Re: Canon Dolomite Quarry, File # 1977-376
Response to Preliminary Adequacy Review for TR #02

**CANON DOLOMITE QUARRY
M1977-376**

TECHNICAL REVISION #2

CANYON DOLOMITE QUARRY
M-1977-376
RECLAMATION PLAN
EXHIBIT F-1

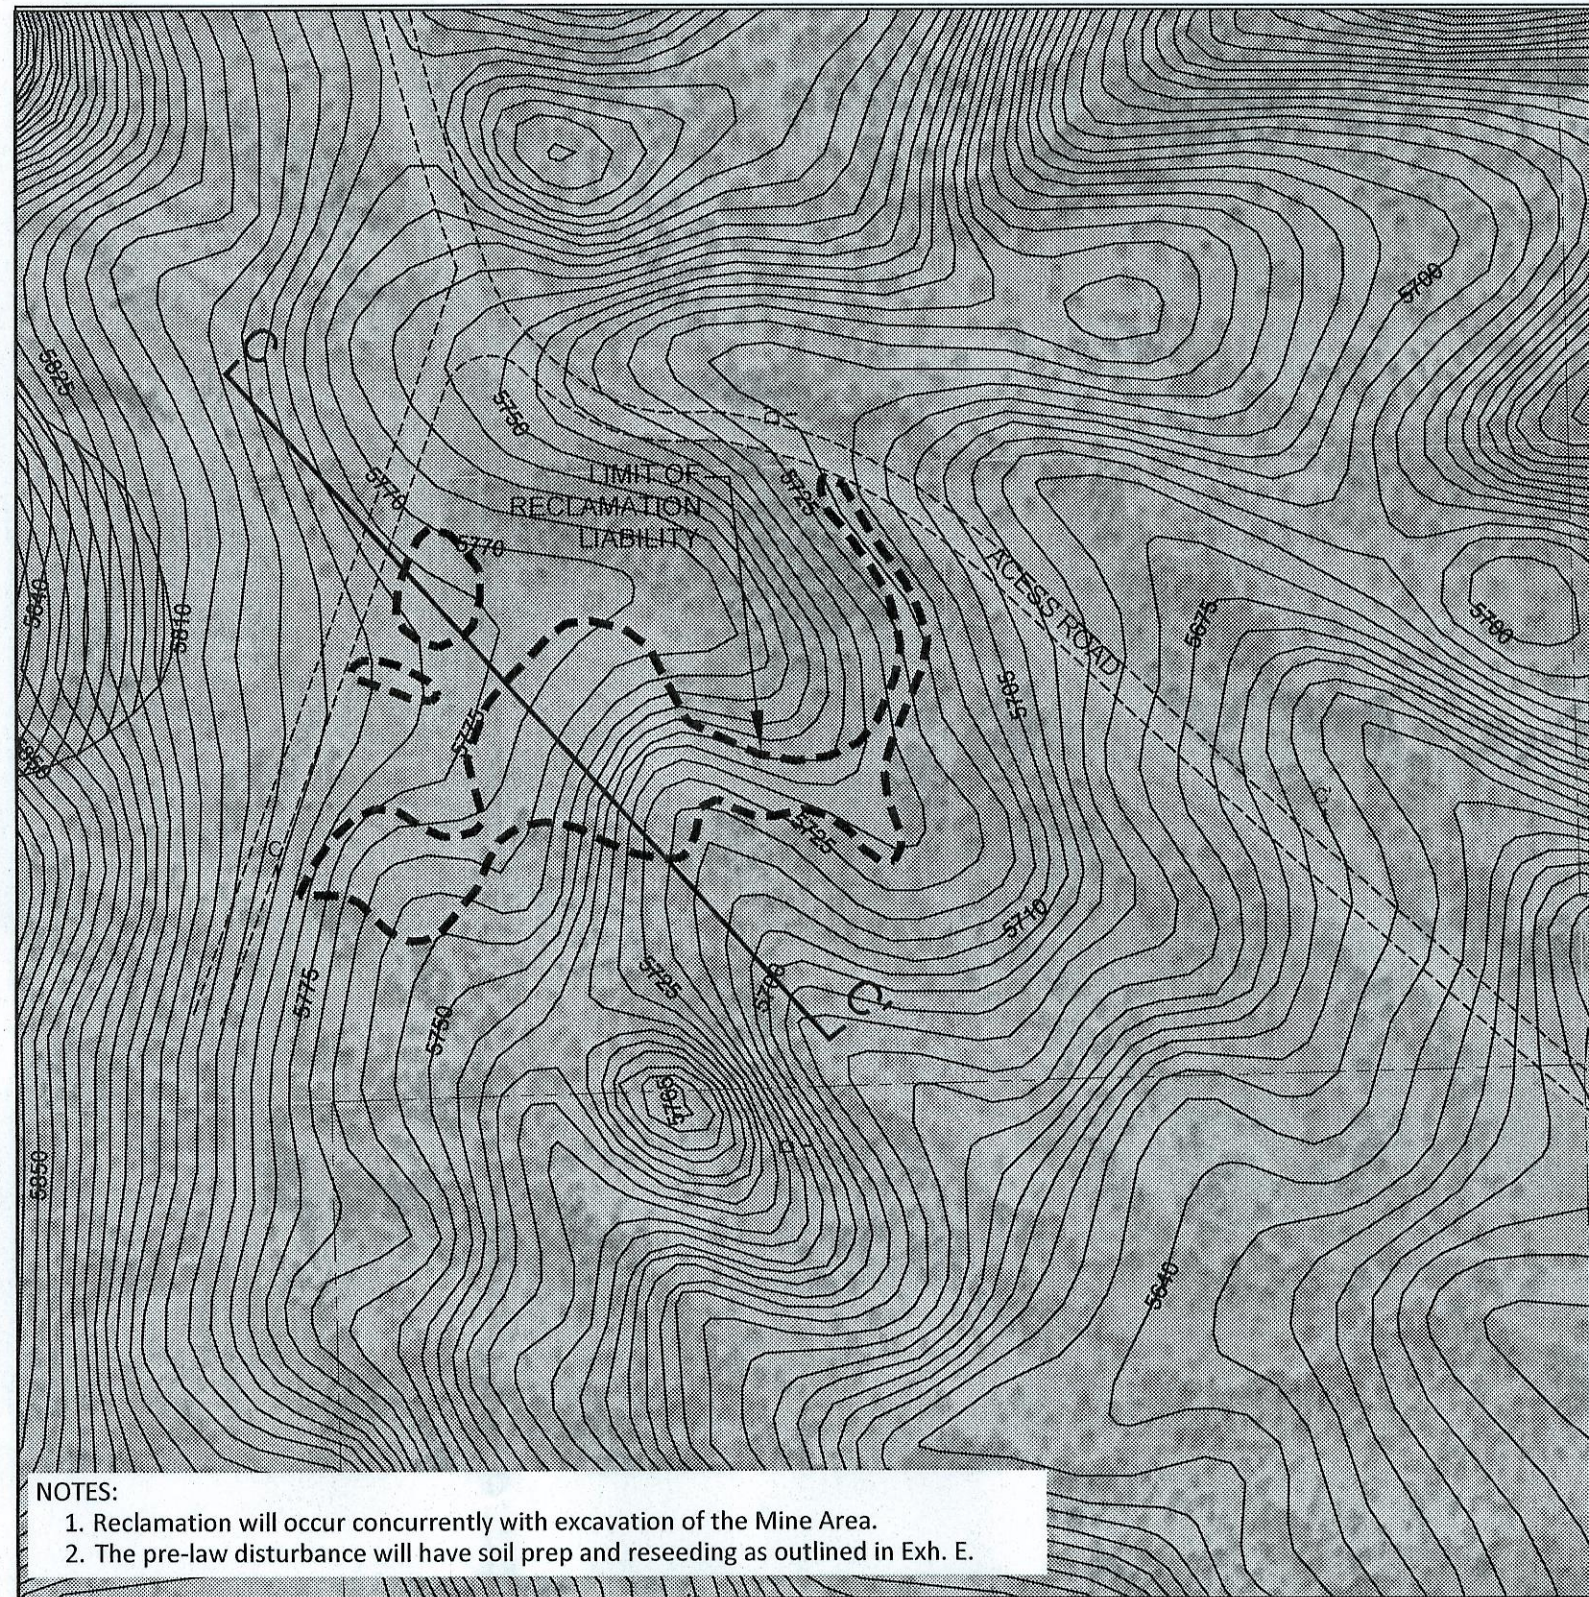
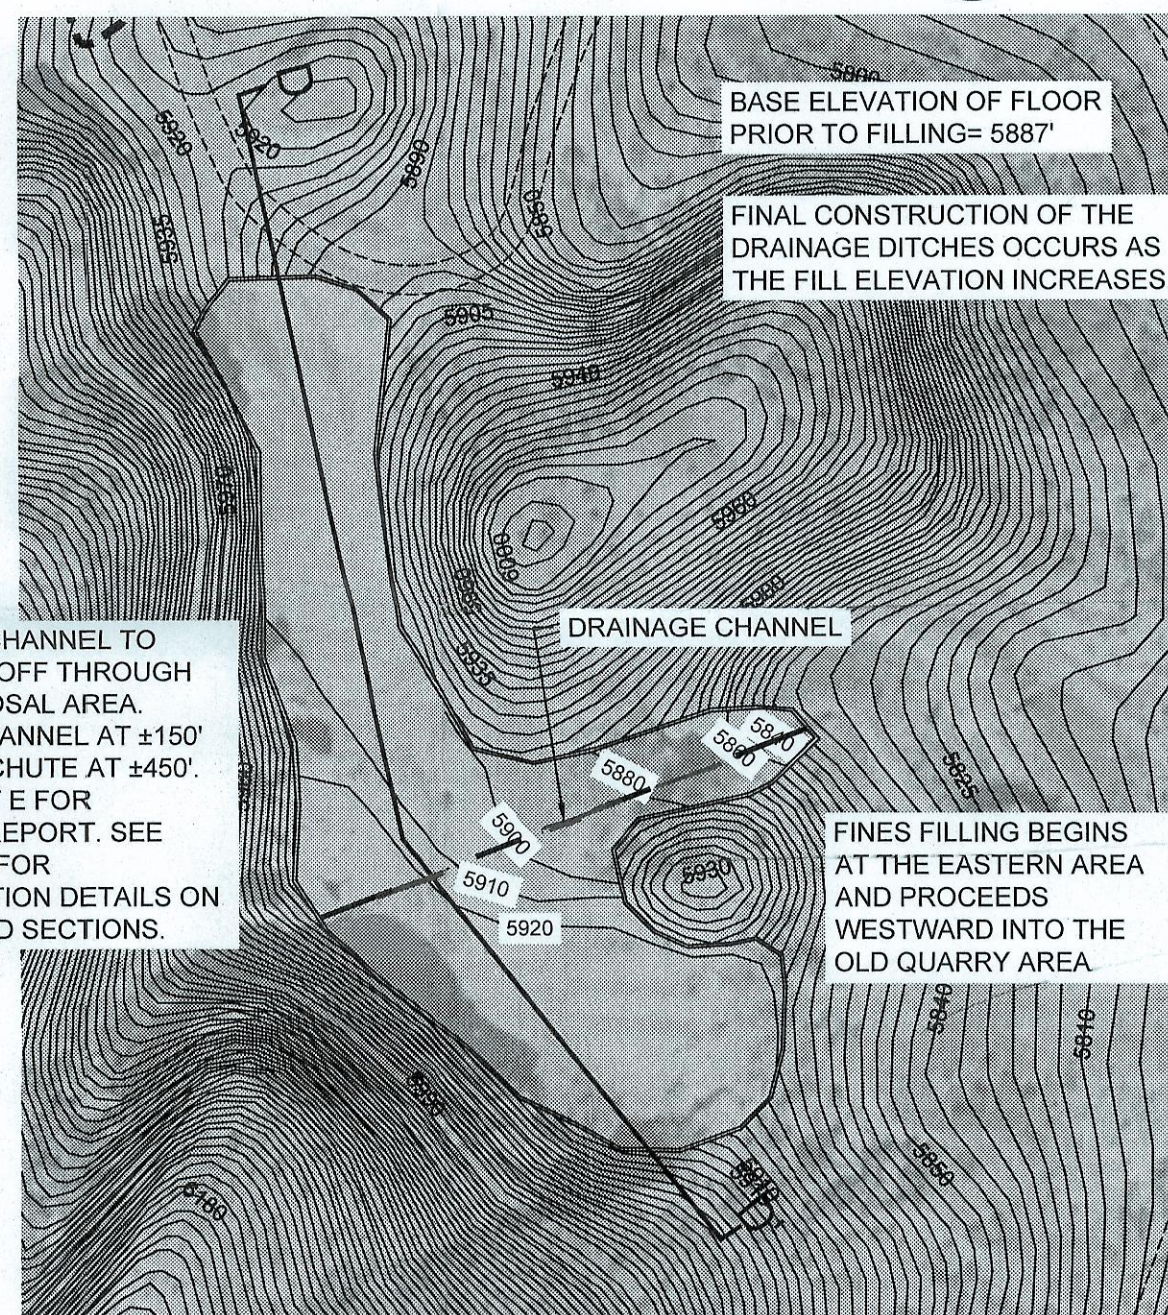
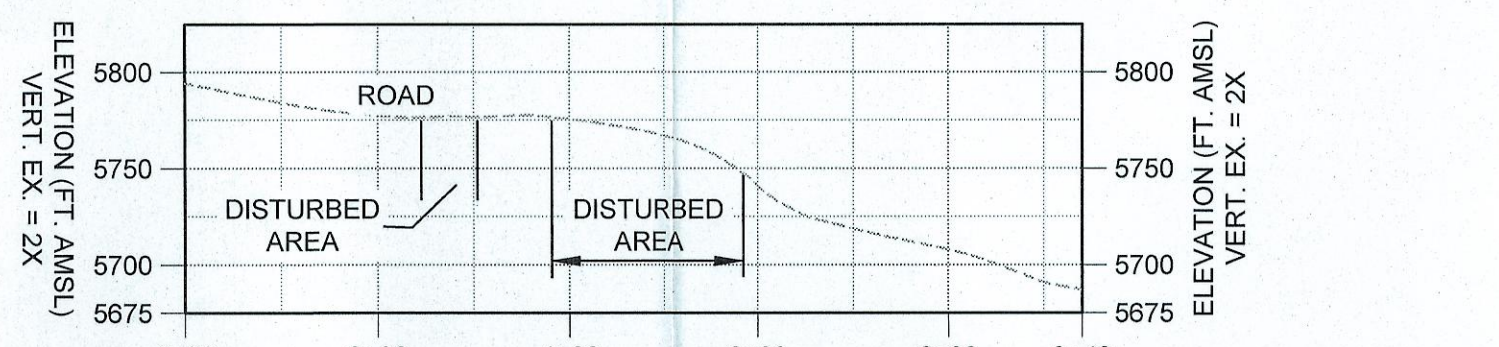
6. Exhibit F, Reclamation Plan
 - a. See explanation in 1.a.
 - b. The proposed mining plan mines over and through the Reclamation Liability Area. Since this area will be mined and lowered in elevation, it will be reclaimed per the proposed reclamation plan, and not reclaimed on the schedule of the Fines Disposal Area (Detail 1).

- c. In Detail 3, all mining disturbance is pre-law.
7. Drainage Report Items 7 thru 12
 - a. Based on your July 13, 2015 meeting with John Jankousky, you both have agreed on the exact requirements of the drainage design in the Old Quarry Fines Disposal Area. To that end, John has revised the Drainage Report and it is enclosed with this letter. Your questions 7 thru 12 should be

PROFILE ALONG CENTERLINE OF ROCK CHUTE
1" = 40'

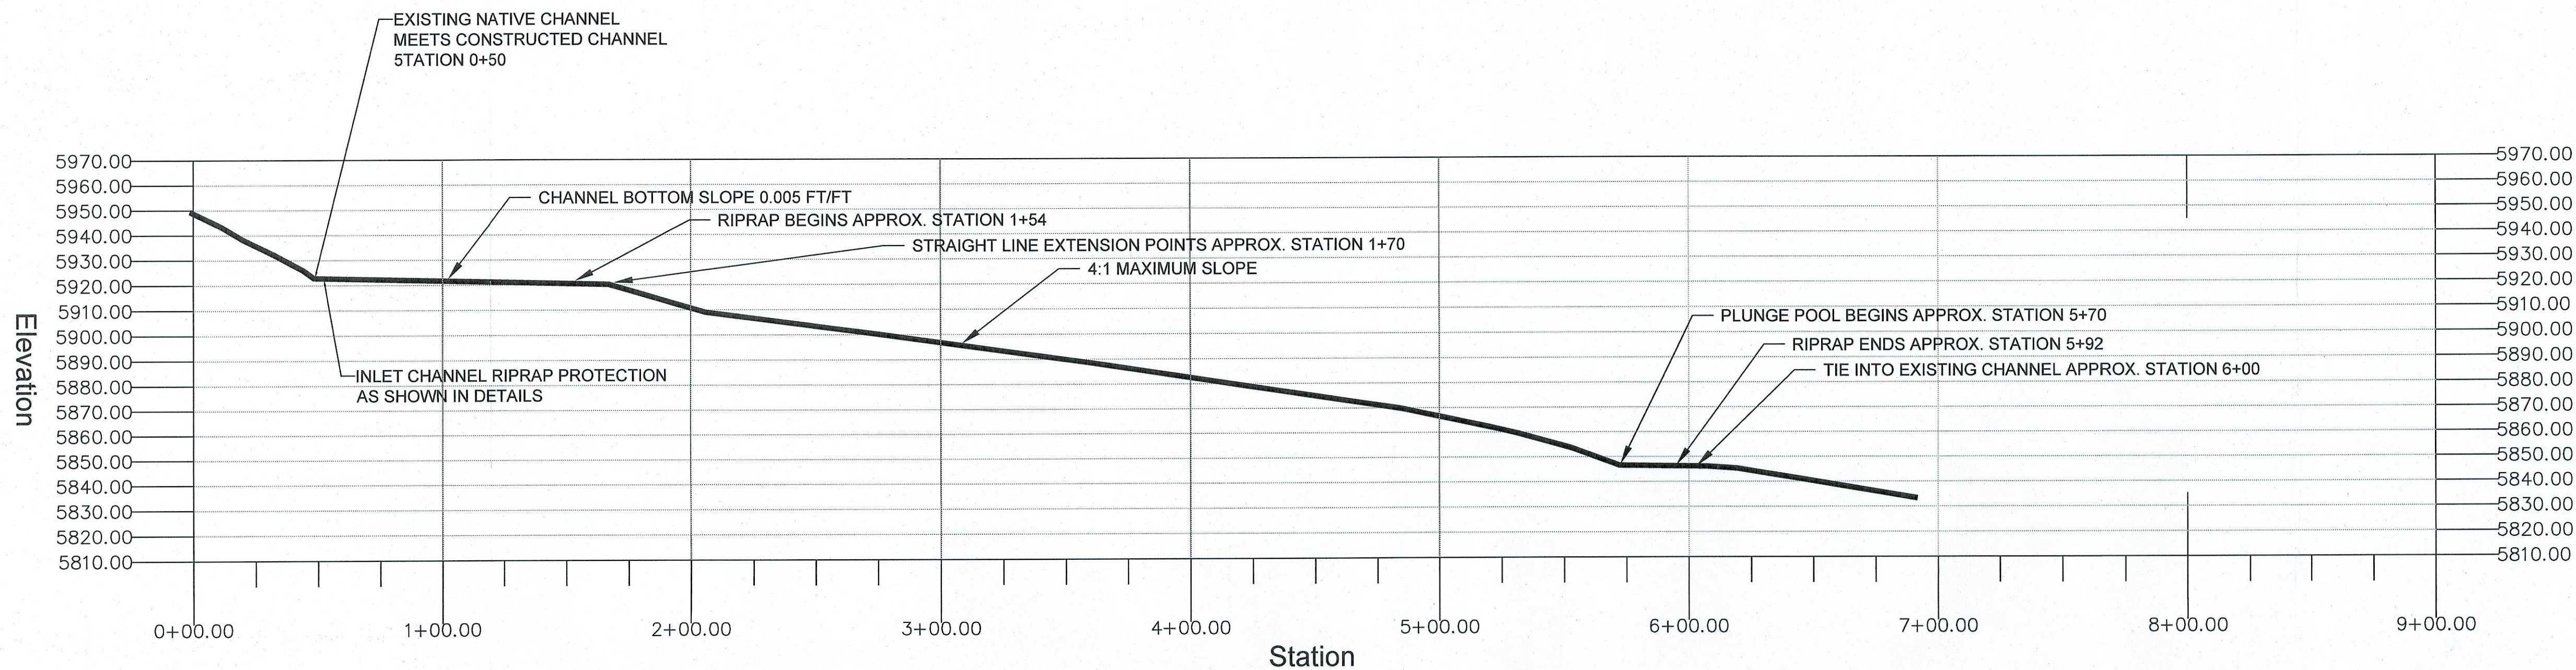
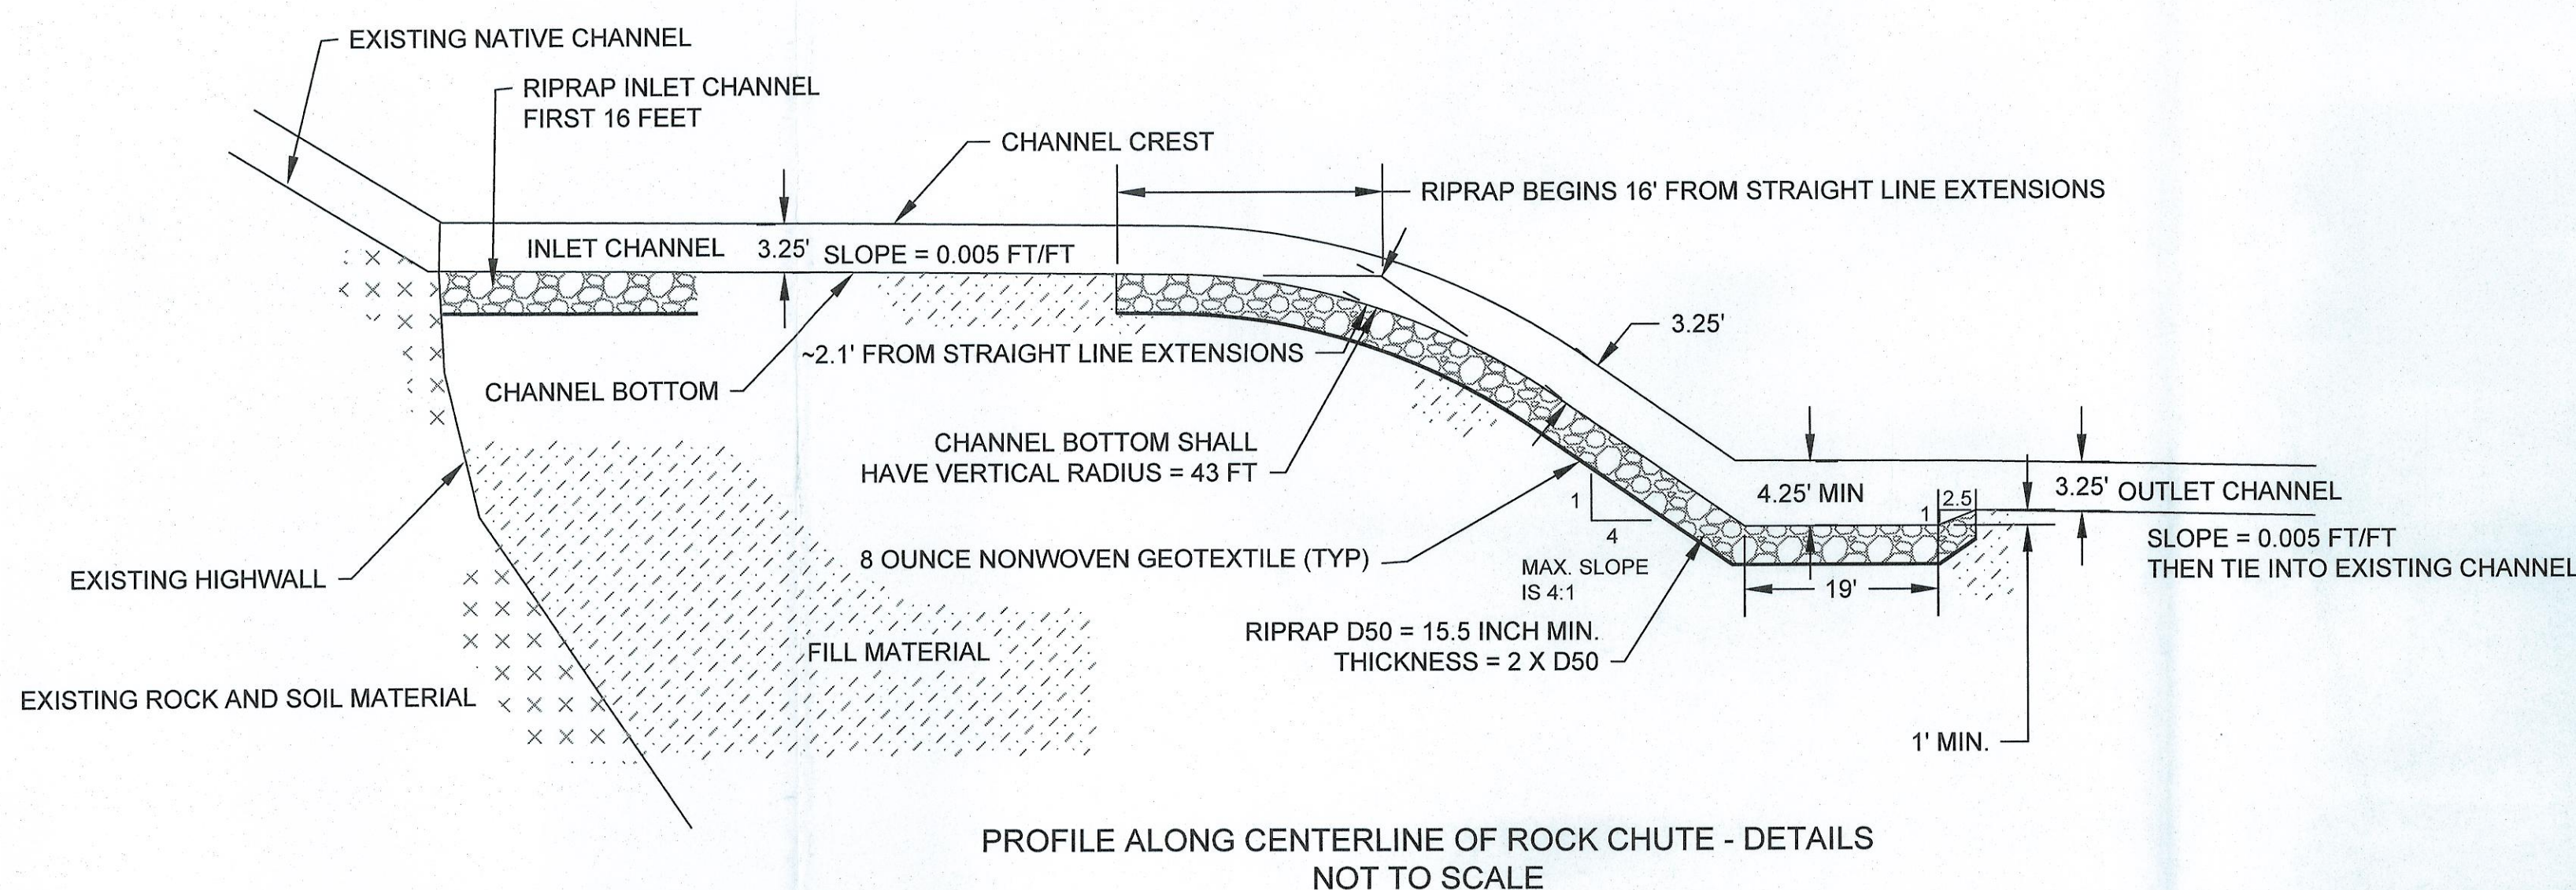
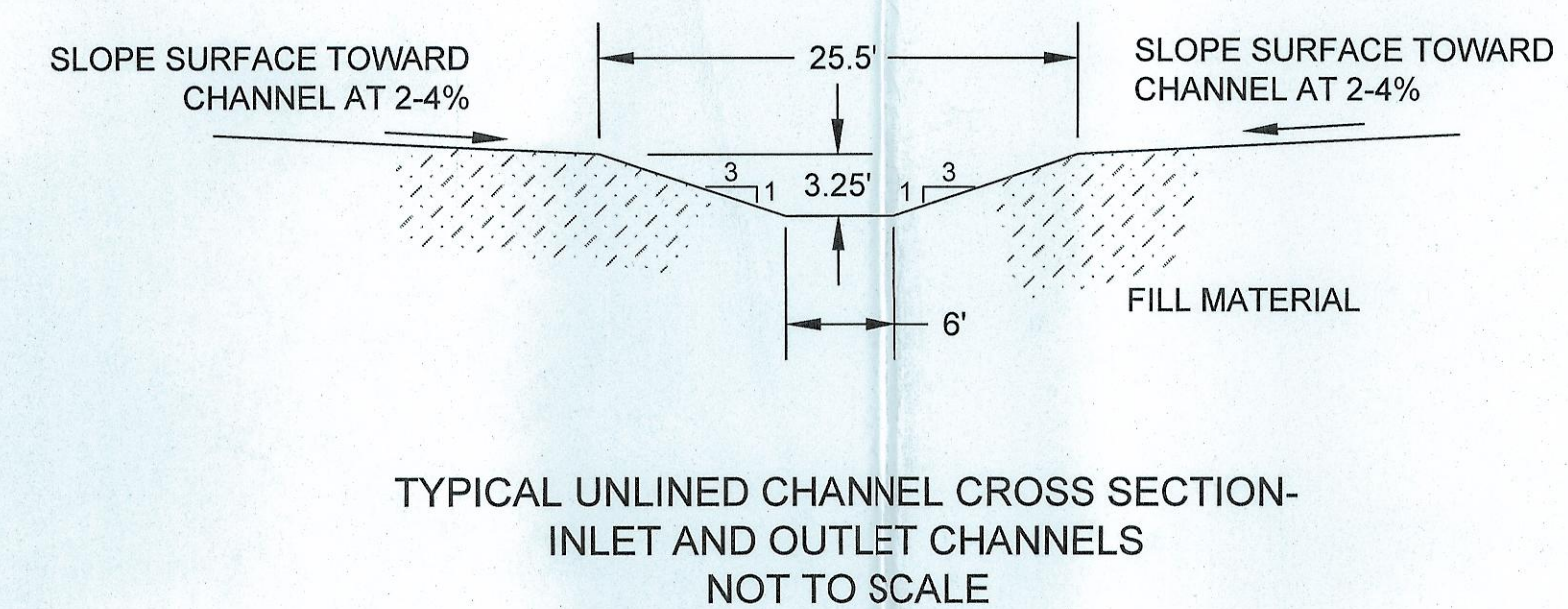
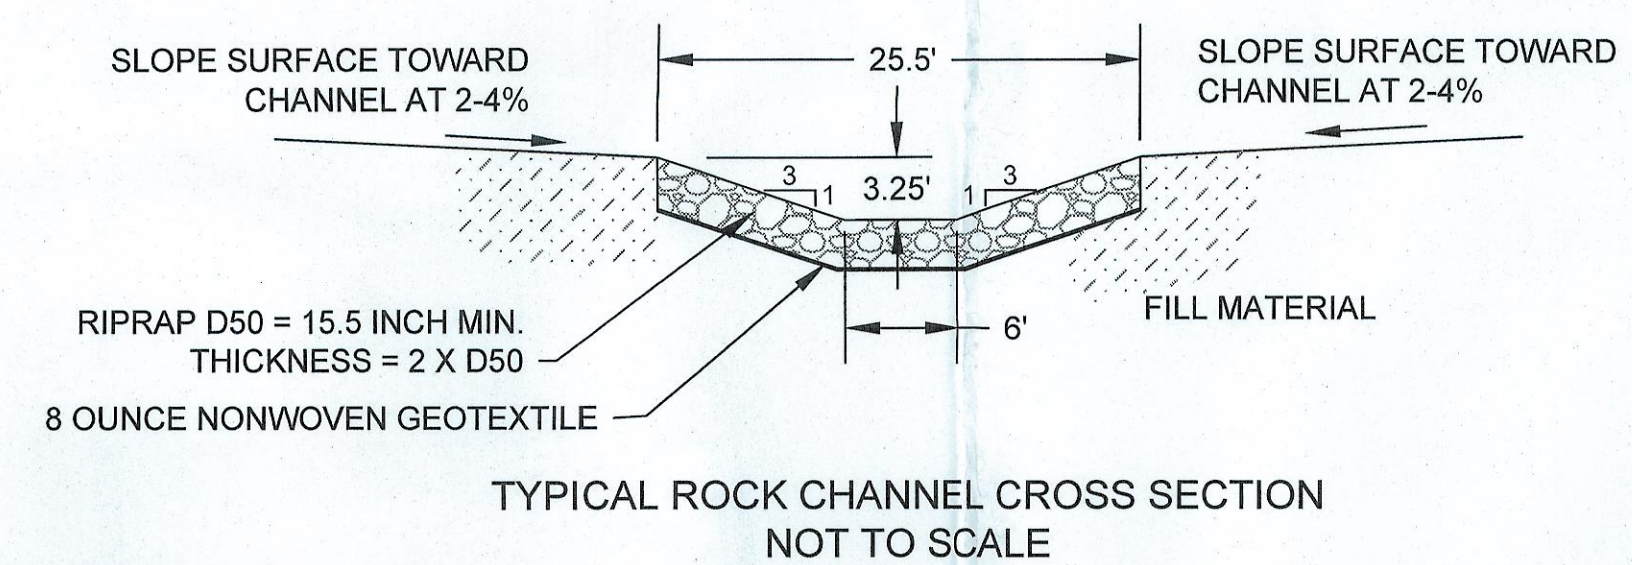
answered in the new report. Also we have produced Exhibit F-2 which contains construction details for the rock chute channel.
